# **Lifetime extension of the French 1300 MWe reactor fleet generic requirements for the 4<sup>th</sup> periodic safety review**

## ***Task 4: Retrofit to State-of-the-Art Report***

**Contracting authority** Bundesministerium für Klimaschutz, Umwelt, Energie, Mobilität, Innovation und Technologie, Sektion VI – Klima- und Energie, Abteilung VI/8 – Allgemeine Koordination von Nuklearangelegenheiten

Figure 1:  
Measures to prevent  
containment breach  
through core melt  
(EDF 2023a).

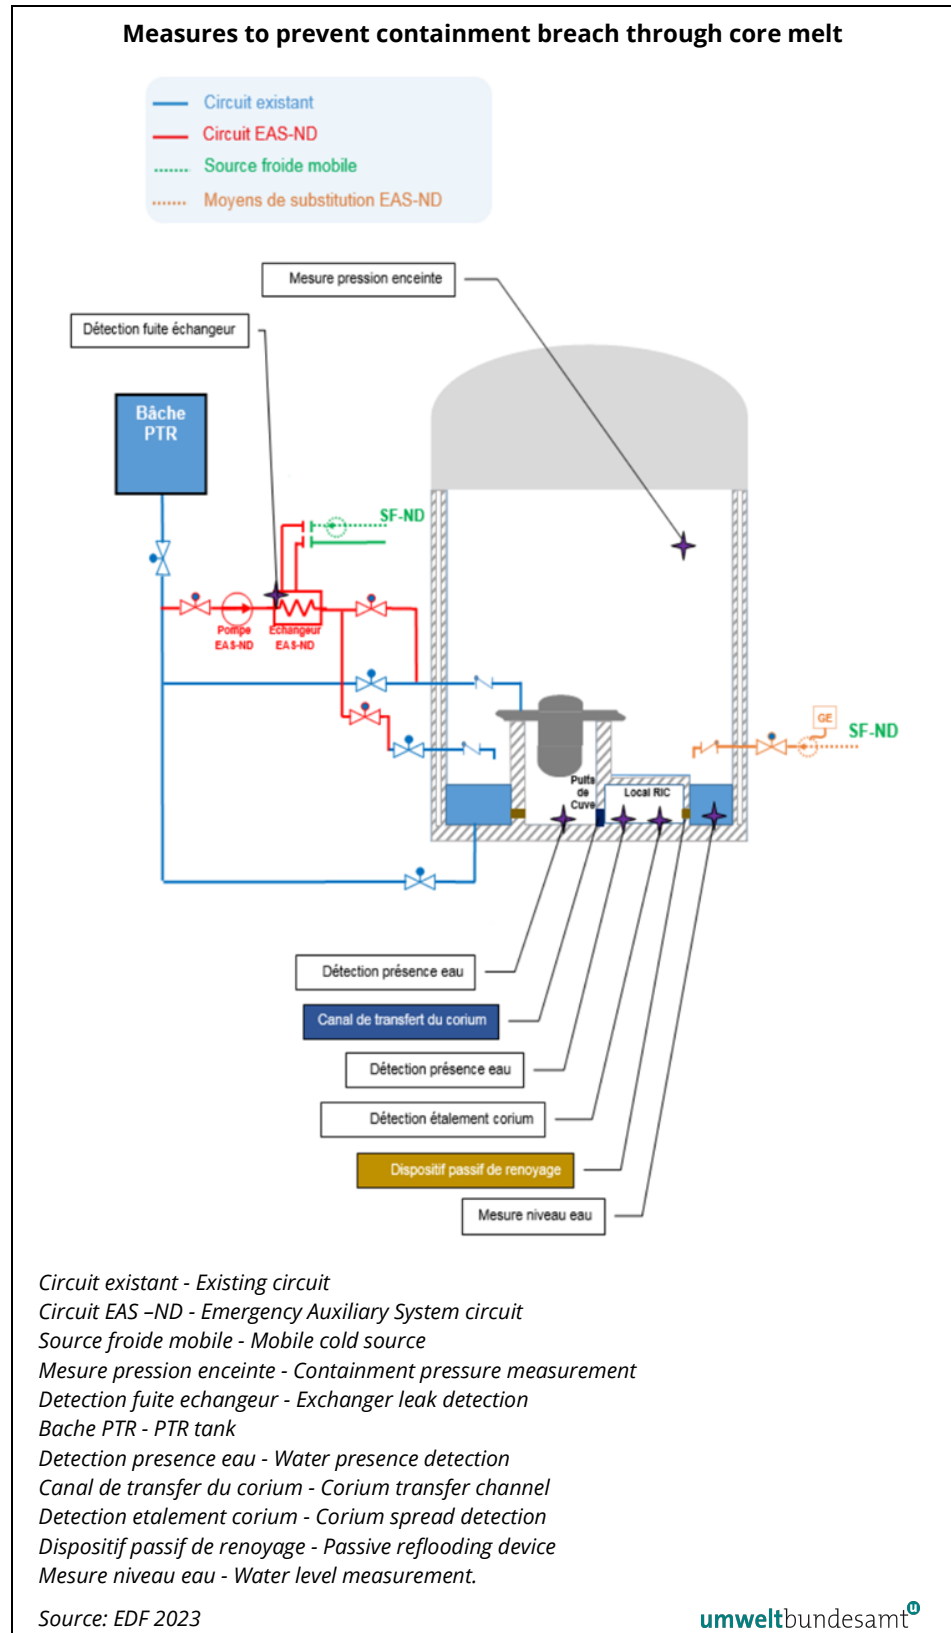
After spreading the corium in a dedicated spreading zone, the molten core is flooded from above. Figure 2 shows the configuration of the 1300MWe fleet corium retention system. Containment sump, reactor cavity and the RIC compartment are located at lowest elevation of the containment. In case of RPV failure and melt ejection into the reactor cavity, a channel between reactor cavity and RIC compartment promotes spreading of the corium. If the containment sump level is sufficiently high, connections from the sump to the reactor cavity and RIC compartment can be opened and facilitate passive flooding of the reactor cavity and cooling of corium from above. Reconfiguration of the SIS allows active injection of water into the sump from the PTR tank, in case the containment sump is empty.

EDF states that the implemented system for corium stabilization is, “in principle, [is] similar to that implemented on EPR (“core-catcher”) type reactors” (EDF 2023a p. 160). In its 2020 statement, IRSN does not address the overall feasibility of the systems but focuses on molten core concrete interaction IRSN 2020d. They assume that, based on the findings, the thickness of the structural concrete slab will be evaluated individually for each system and reinforced accordingly.

The effectiveness of the system, however, depends, among others, on the coolability of the corium by flooding it from above. In the event of RPV failure and melt ejection into the cavity, a pool of corium accumulates at the bottom of the reactor cavity. Cooling water is then provided from above and will cool the corium by evaporation. The steam is condensed by the containment spray sys-

tem and accumulated again in the containment sump. The key question, however, is how effective the pool of corium can be cooled by pouring water onto it from above. The current state of knowledge is that a crust would form on top of the pool of corium, preventing further heat removal. Below the crust, MCCI would proceed and sooner or later lead to containment failure (ASN 2024a). Regarding MCCI, the effectiveness of corium stabilisation management has been only provided for certain types of concrete. Demonstration is still needed for the mainly very siliceous concrete used in the 1300 MWe reactors (ASN 2023).

Figure 3:  
Schematic illustration of  
the mobile cooling sys-  
tem PTZ bis (EDF 2023a).

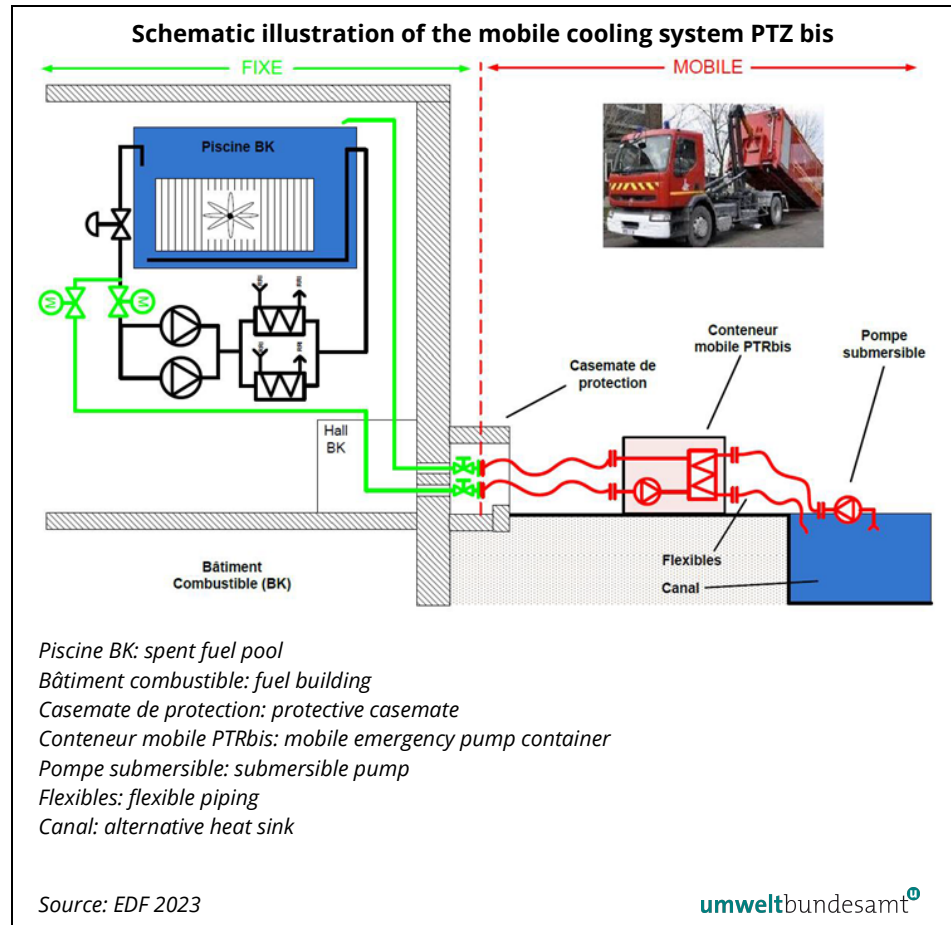
For the 1300 MWe reactor fleet, there are two cooling trains. However, those rely on the same water supply and are not completely separate (Mertins 2021 p. 47). Electricity can be supplied by the emergency diesel generators. Spent fuel pool condition instrumentation has been reinforced and is part of the HSC (ASN 2020). At least for the 900 MWe reactor fleet, ASN stated that “the initial design and the current state of the spent fuel pools falls significantly short of the safety principles that would apply to a new facility” (ASN 2016a).

In case of failure of the two trains and the consequent loss of spent fuel cooling, a third train is to be provided by FARN using mobile equipment (PTRbis). For this case, the necessary piping has been permanently installed in the facade of the fuel building. However, this system is also not completely separate from the existing cooling trains (EDF 2023a).
